Steam Generator Inspection Program and Results

Answers to Questions

Indian Point Unit No.2
Docket No. 50-247
May, 1978

ROWS

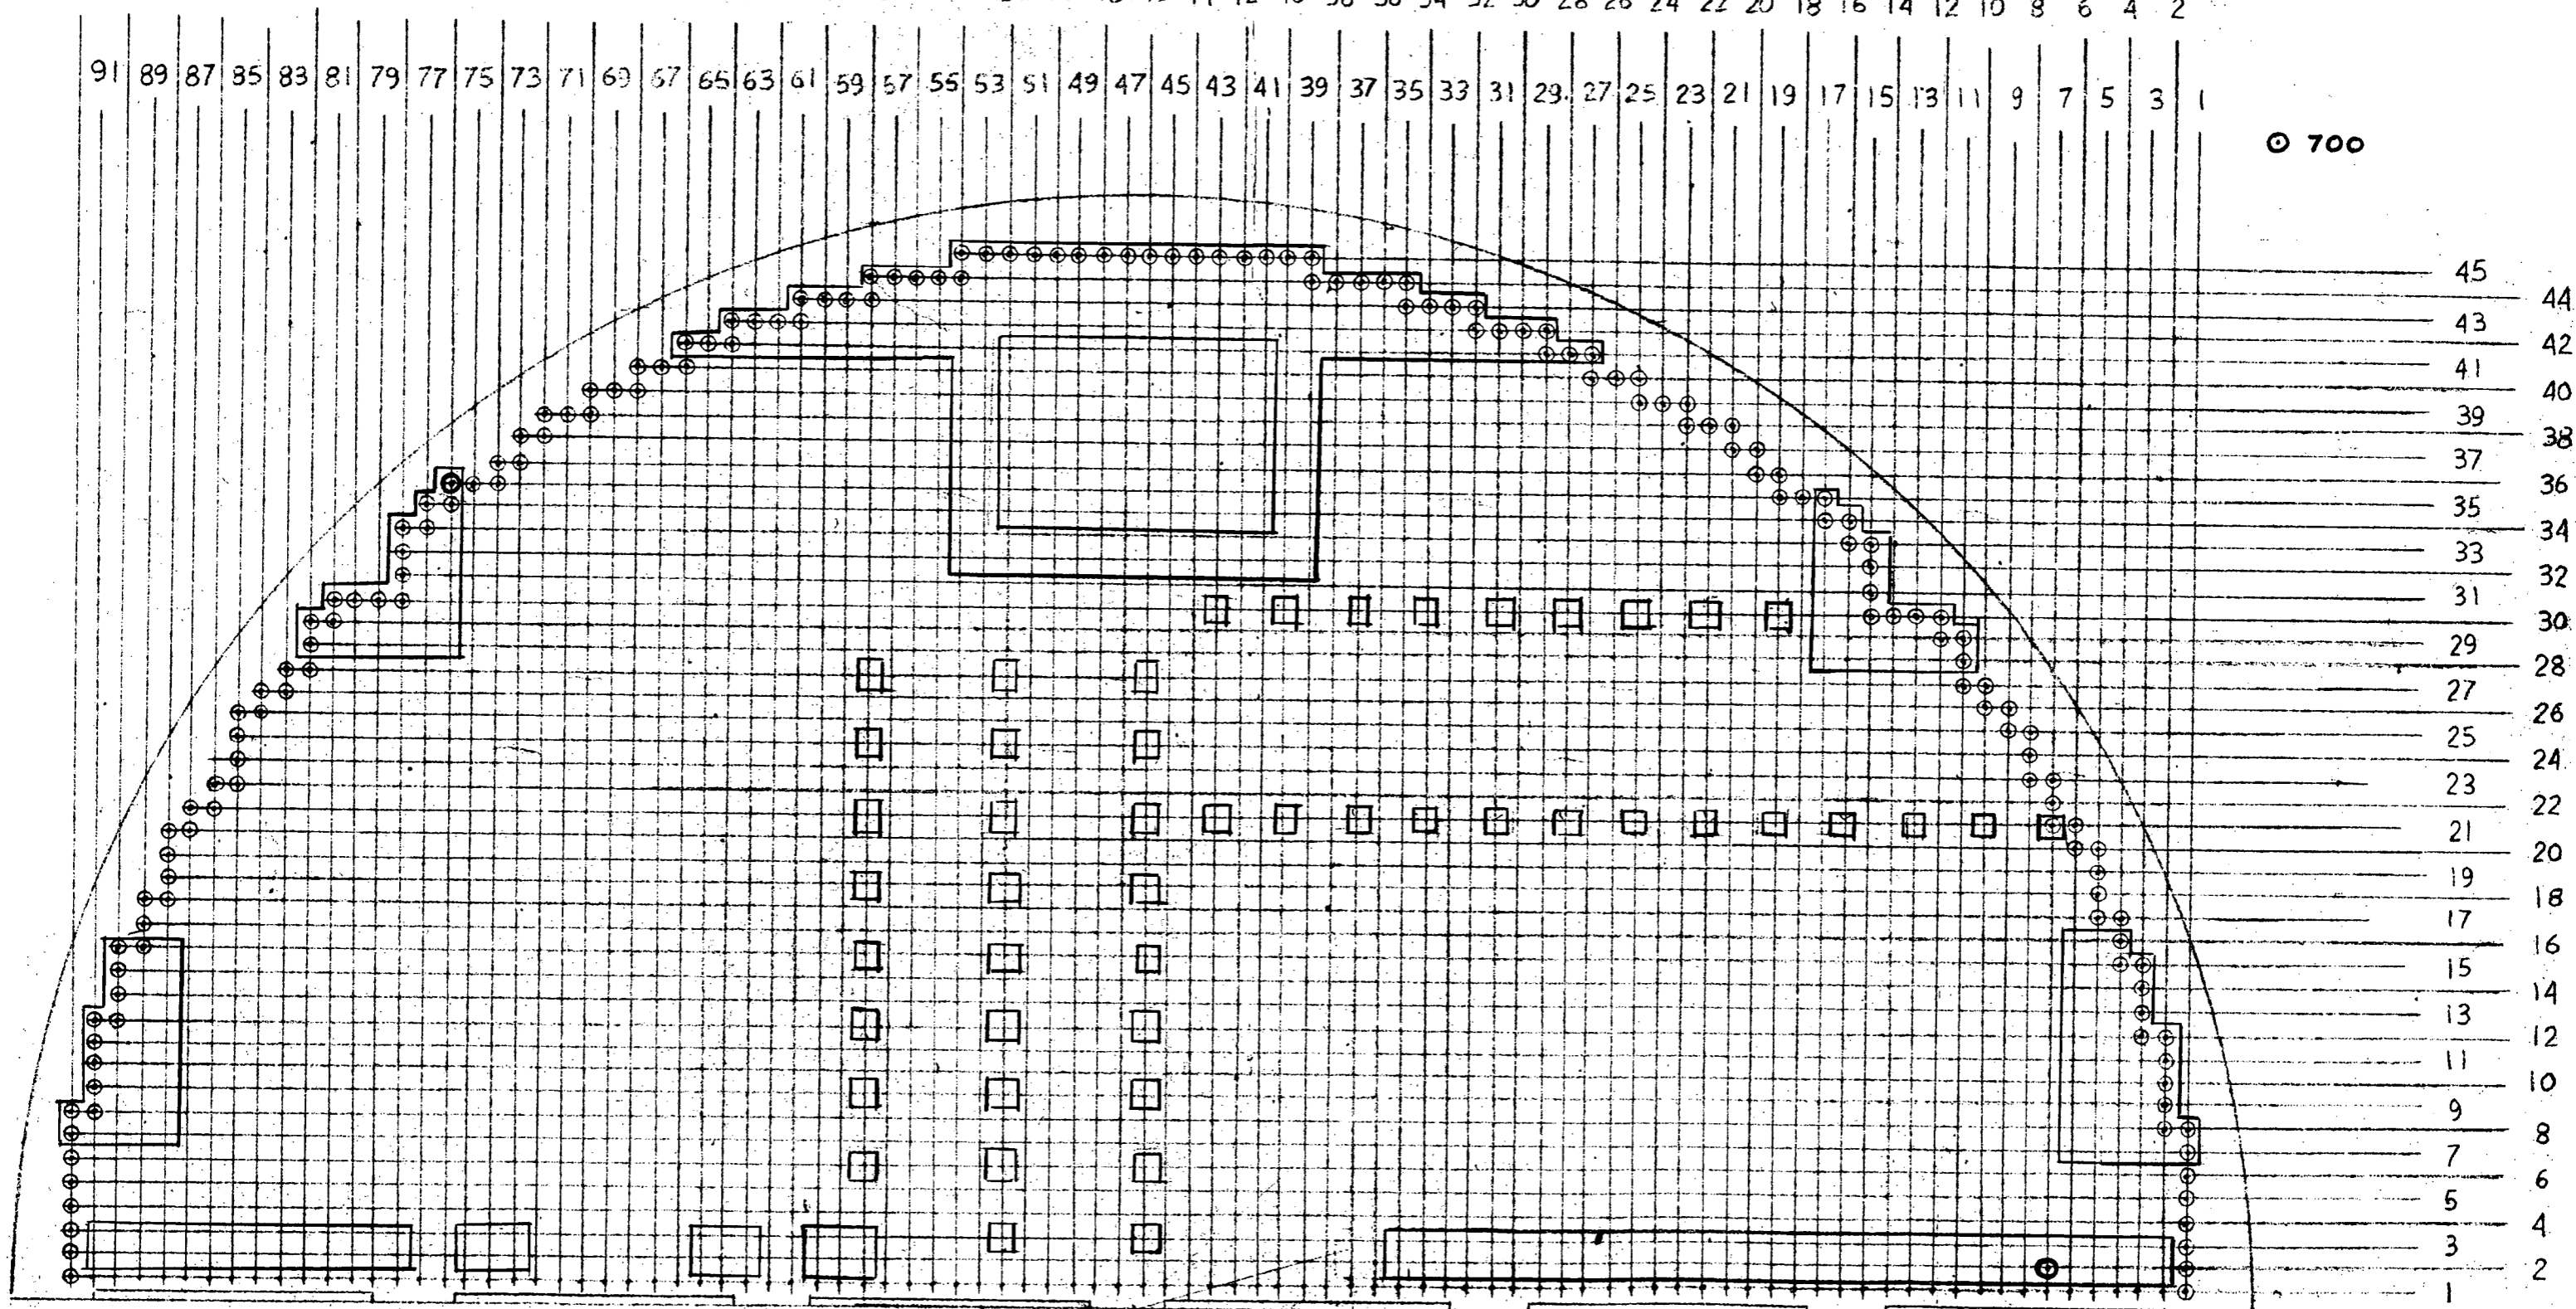
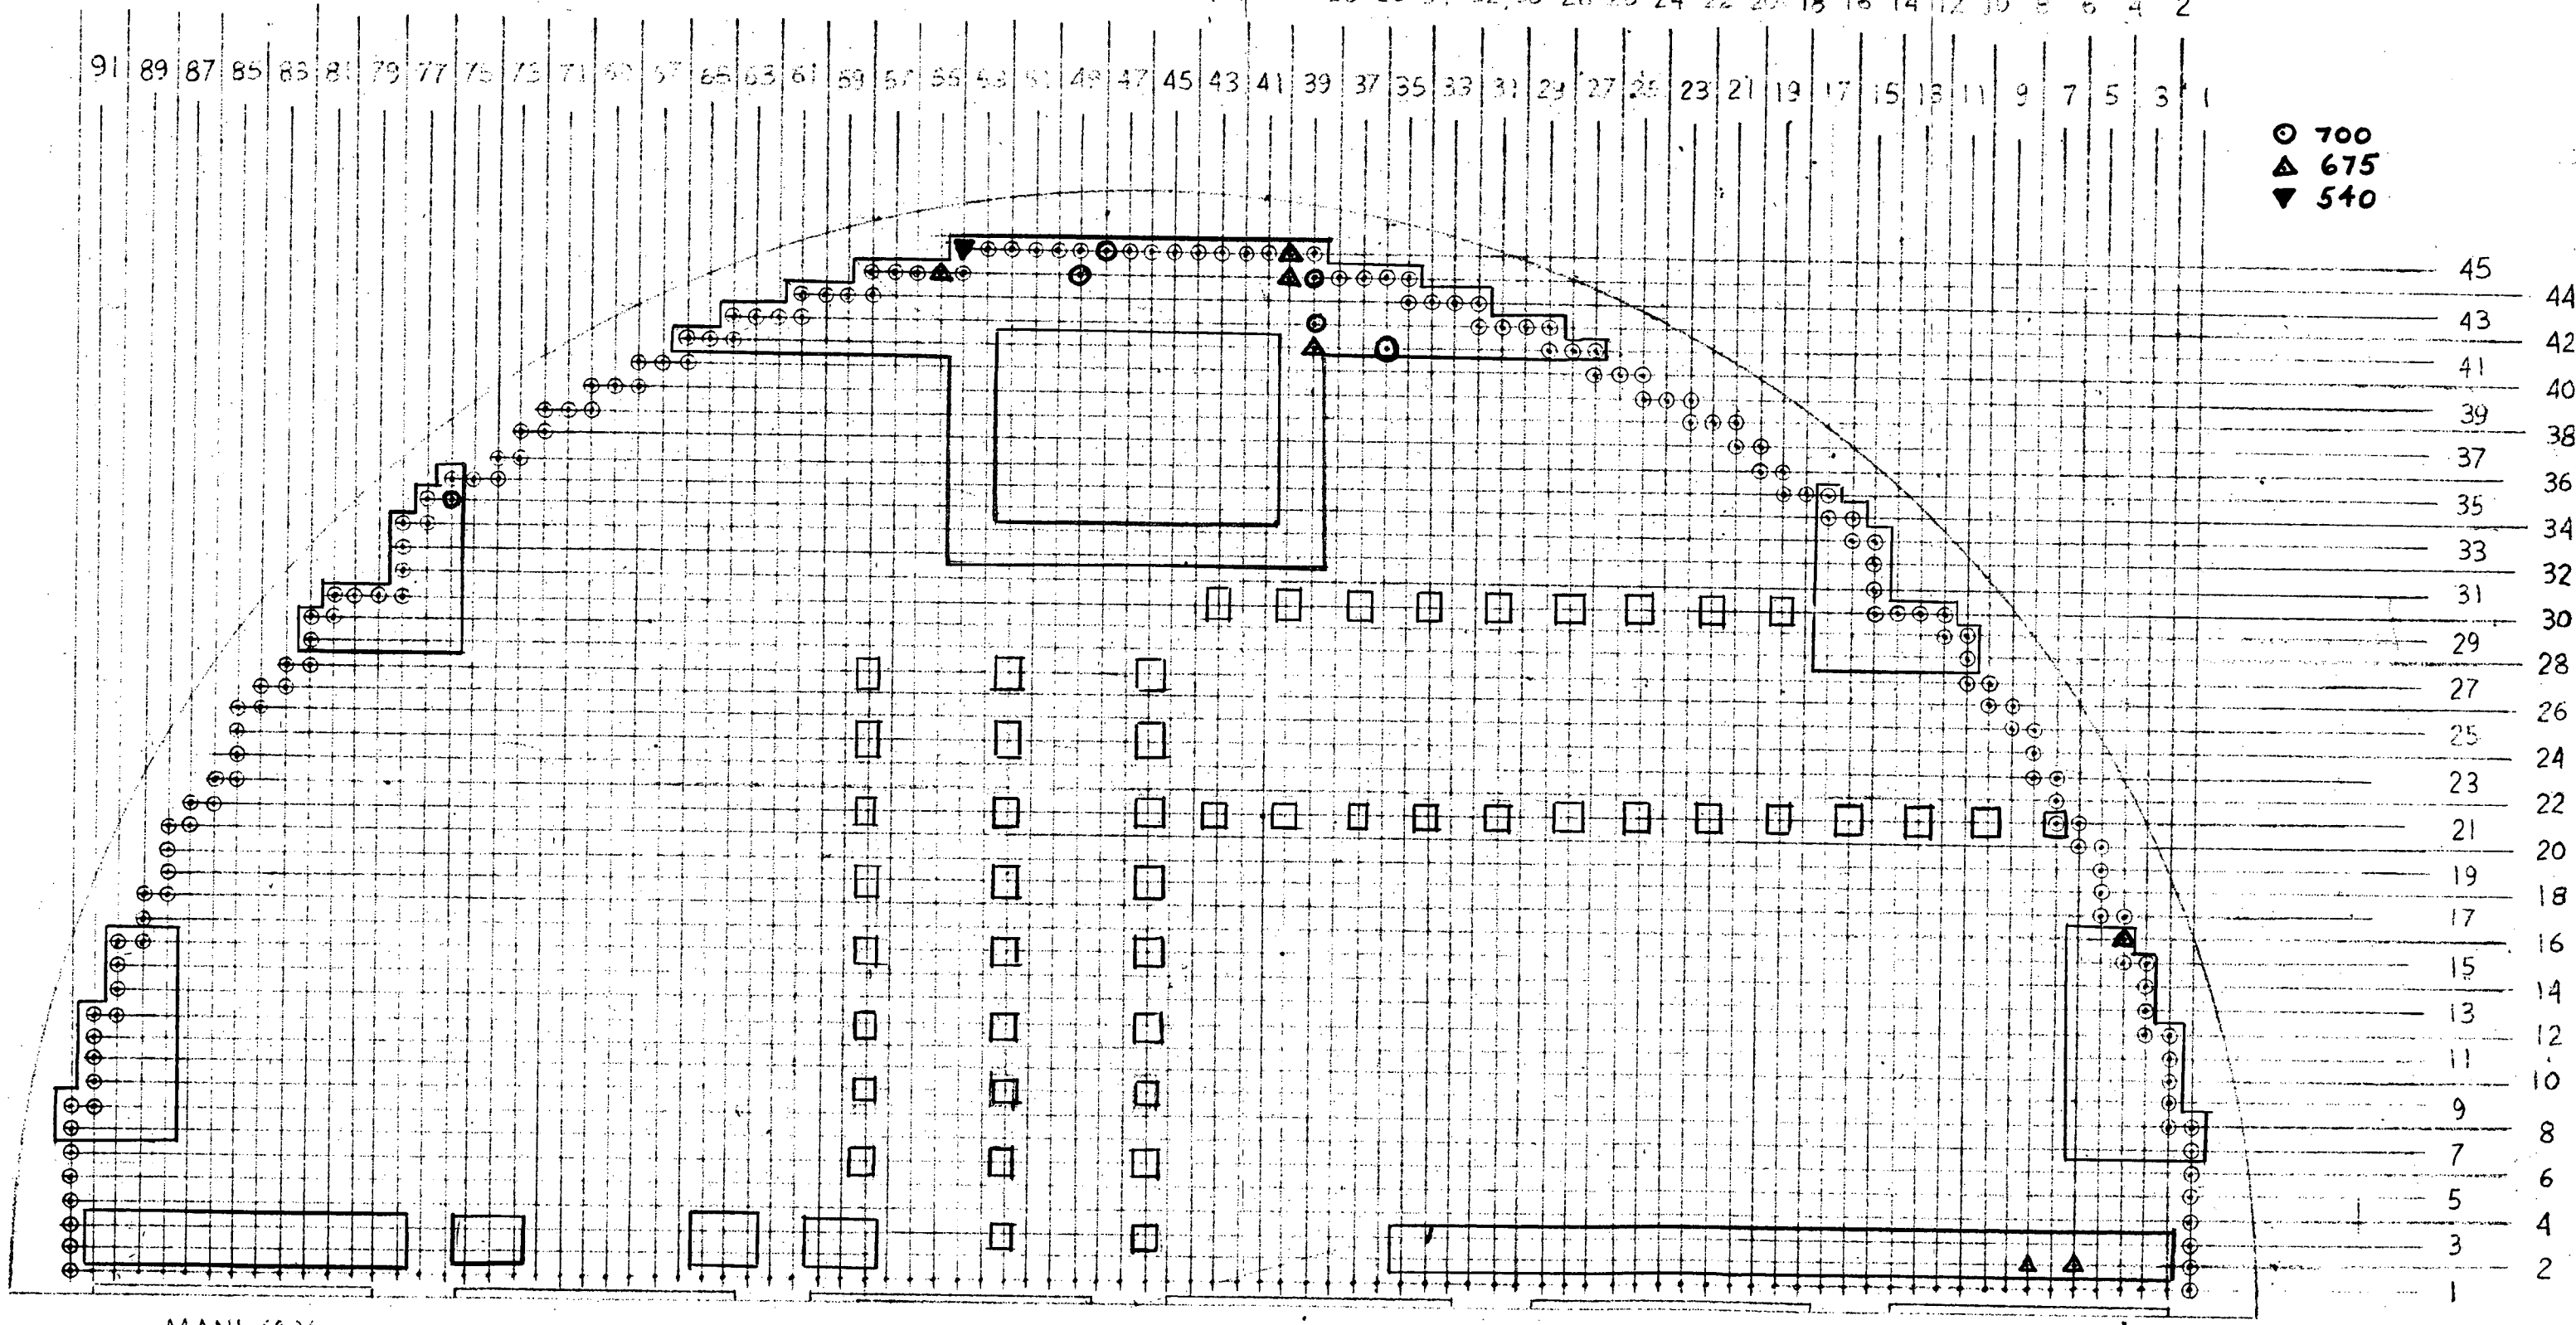
Please provide a map which shows the locations of steam generator tubes tested during the March, 1978 inspection which did not permit passage of the standard 700 mil eddy current probe.

Maps of the locations of all tubes which did not permit passage of the standard 700 mil probe are forwarded as Attachment B to this letter. These locations are coded to indicate the smallest probe size that would not pass through the tube. Those tubes for which the 700 mil probe was the smallest probe size not able to pass through the tubes are indicated by the heavily drawn circle at those tube locations.

The distribution of tubes which permitted passage of probes smaller than the 700 mil diameter probe is slightly different from that shown in our March 24, 1978 submittal because the tubes were reprobed and the data tabulated below is the most recent:

<u>Steam Generator 23</u>		<u>Steam Generator 24</u>	
<u>Smallest Probe Not Passed by Tube</u>	<u>Number of Tubes</u>	<u>Smallest Probe Not Passed by Tube</u>	<u>Number of Tubes</u>
700 mil	28	700 mil	55
675 mil	16	675 mil	7
640 mil	1	640 mil	2
610 mil	1*	610 mil	3*
540 mil	1*	540 mil	3*

*Plugged during 3/78 inspection program
